Expert Hydrogeological Report Addendum

Board of Inquiry, McCrae Landslide

Date
11 August 2025

Figure 1 - BH02 picture of granite core from screened interval of bore

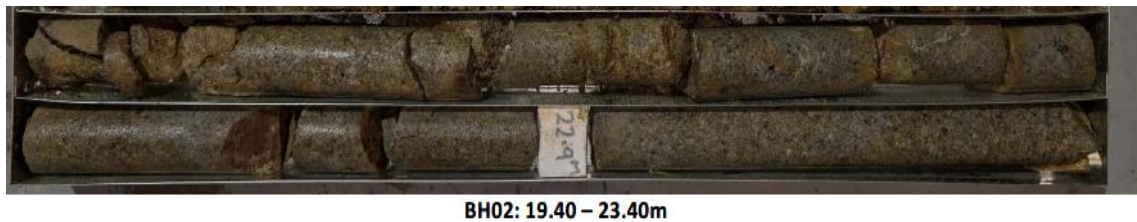
- While I agree with the flow equation used (based on Darcy's law) there are issues with the input parameters as presented below:
 - Permeability - worksheets of the raw data are not provided so the results can't be verified;
 - Permeability - the graph in the calculation sheet for BH04 (colluvium) shows only limited recovery of drawdown, and
 - Porosity - in my opinion the porosity value of 0.2 used in the lower flow calculation is very high (the SMEC logs describe the granite as massive, refer figure 1) and should be around 0.05⁴ which would reduce the flow rate significantly (by a factor of 4).
